# Access Compliance Report Public Rights-of-Way (Curb Ramps)

Main Street: DONOVAN\_RD Cross Street: SILVERWOOD\_DR Location: E

ADA ID: RPAT211202121739 Ramp Type: Type 1 - Perpendicular Diagonal Initial Pass/Fail: Pass Overall Compliance: No Severity Score: 14

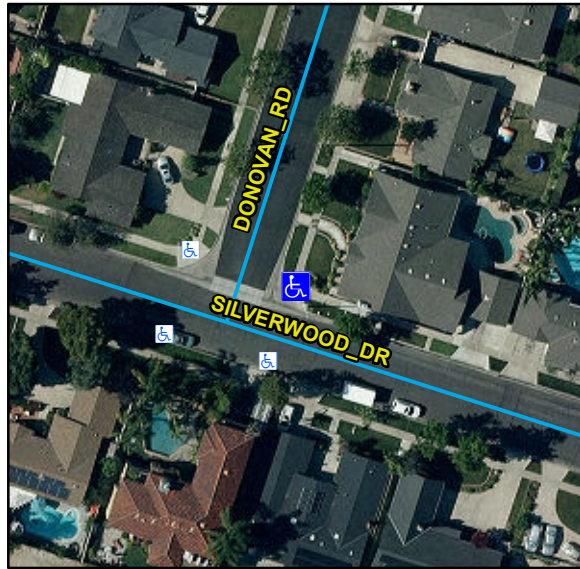
| Compliance | Description                           | Data   | Compliance | Description                   | Data   |
|------------|---------------------------------------|--------|------------|-------------------------------|--------|
| No         | Landing Run Slope (%)                 | 2.7    | N/A        | Flare Traversable RT          | No     |
| Yes        | Landing Cross Slope (%)               | 1.5    | No         | DWS Provided                  | No     |

Remove & Replace Curb Ramp With Two New Directional Ramps or Equivalent.

R204.3, R304.2.1, R304.2.2-Perp, R304.3.2-Para, R305, STD 1115
